SERVICE BULLETIN

TRANSMISSION &
CLUTCH
REFERENCE _____
NUMBER 024
DATE 11-10-89
MODEL AE, AW, ST, SV

C5# AND S5# DIFFERENTIAL PINION SHAFT MODIFICATION

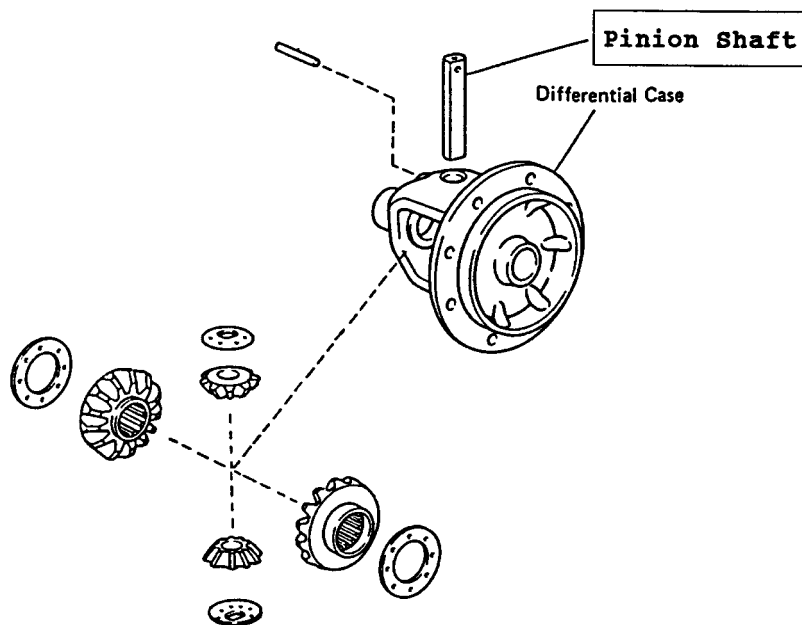
To improve the durability of the Differential Pinion Shaft, the surface treatment has been changed. The modified Differential Pinion Shaft may be used on previous vehicles with C5# and S5# Series Manual Transmissions.

To identify the old Pinion Shaft from the new one, the surface color has been changed.

PREVIOUS	NEW
COLOR OF PINION SHAFT	GRAY	GOLD
